I-5 HOV AND TRUCK LANES PROJECT

EA No. 07-2332E0

PM2.5/PM10 HOT SPOT ANALYSIS RESPONSE TO COMMENTS

FHWA Comments

FIGURE 2

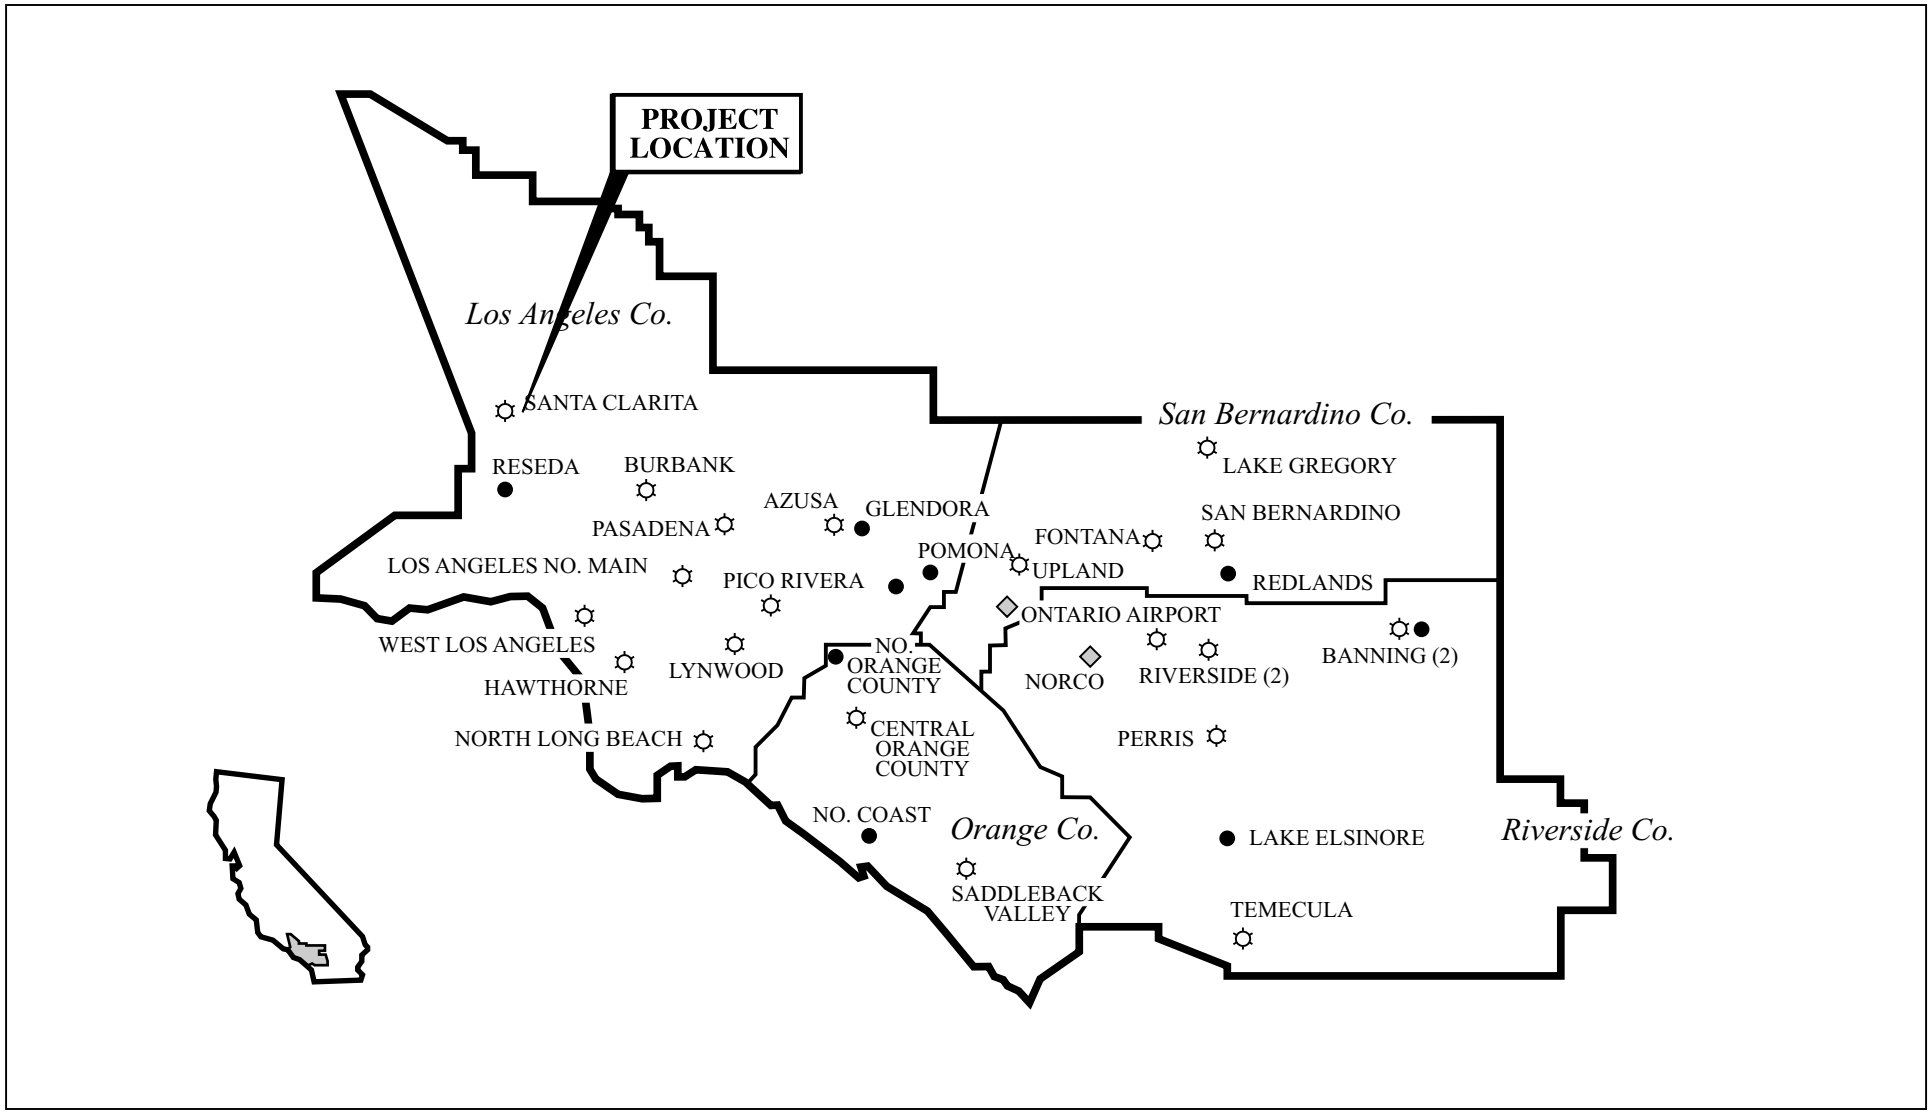
Comment #2: Data Considered. The analysis should include a map showing the location of the monitoring stations in relation to the I-5 and the project under analysis and should list the total approximate volumes of traffic at the roadways near the monitoring stations, not just the truck volumes.

Response: A map showing the project location relative to the monitoring stations has been added to the analysis. The total daily traffic volumes along I-5 have been added to the truck traffic volumes in the revised analysis.
